Addendum No. 01 (One)

Date: 05/09/2025

Project: IN000A Site - Parking Lots 28 & 93 Repairs and Modifications

IU Project No: 20240389

SHEET NAME: CG-101 GRADING PLAN

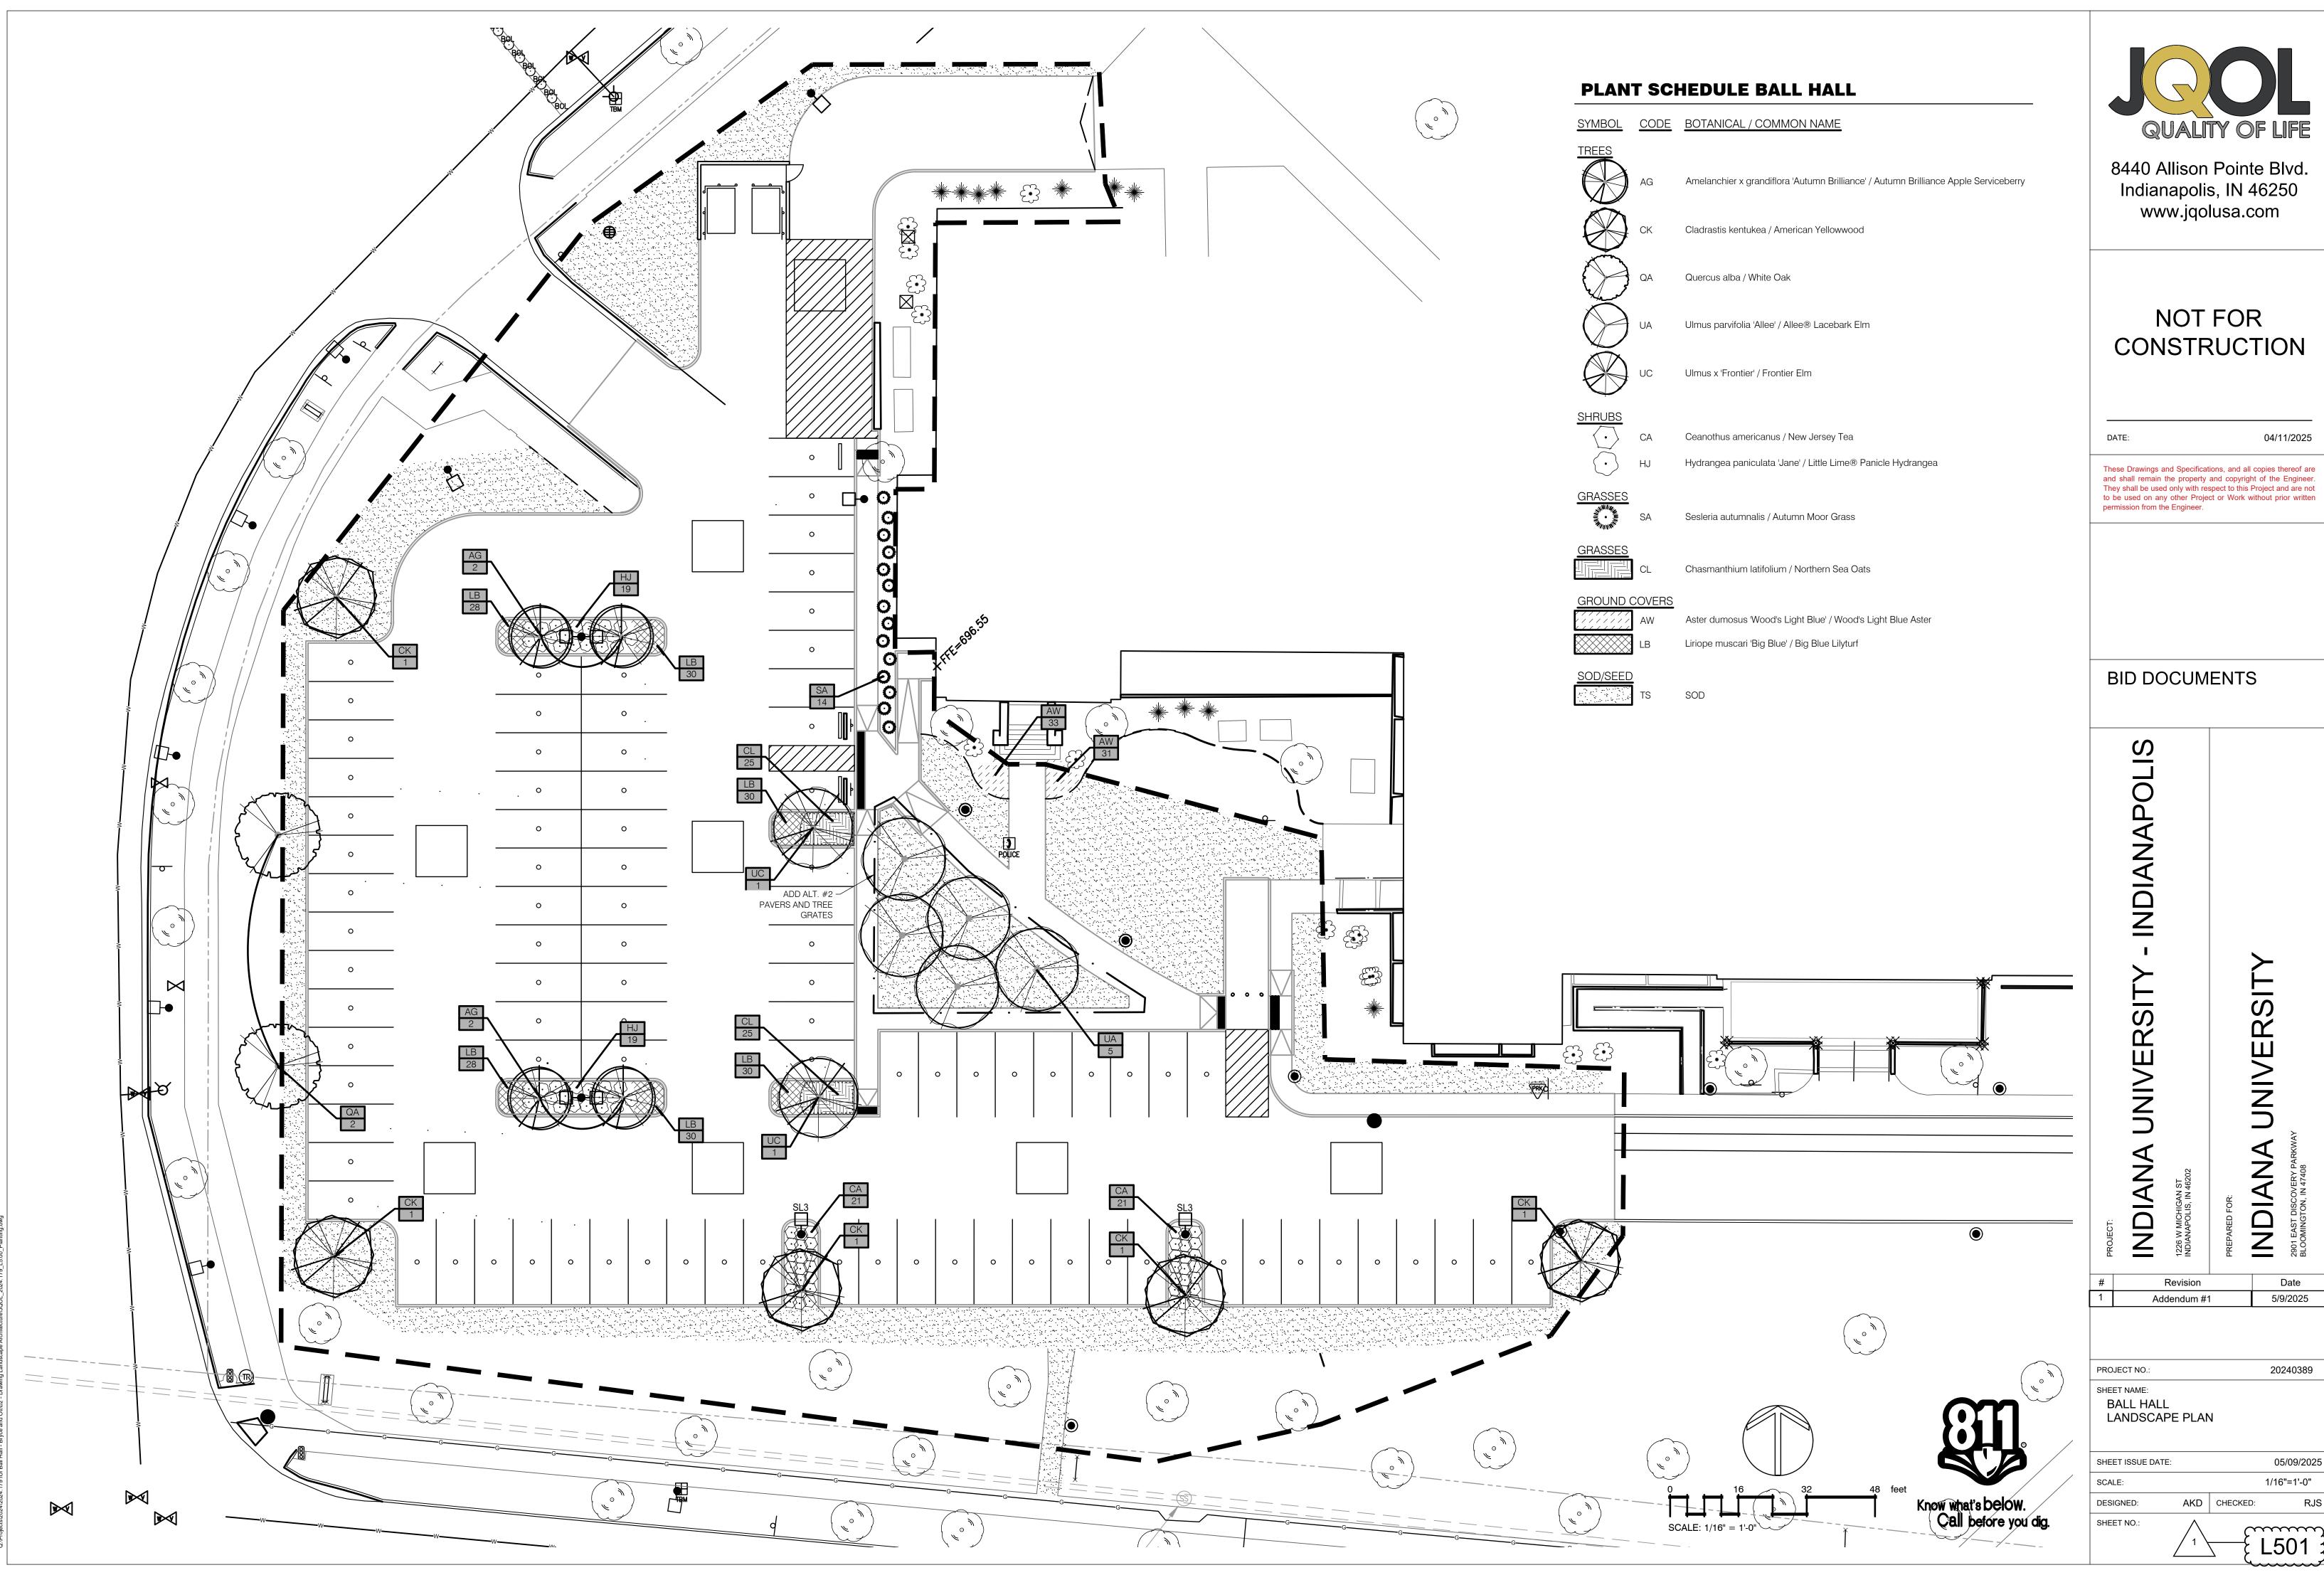
- Update to grading plan adjusted grades at the curb ramp
- Update to grading plan updated grades at the north entrance
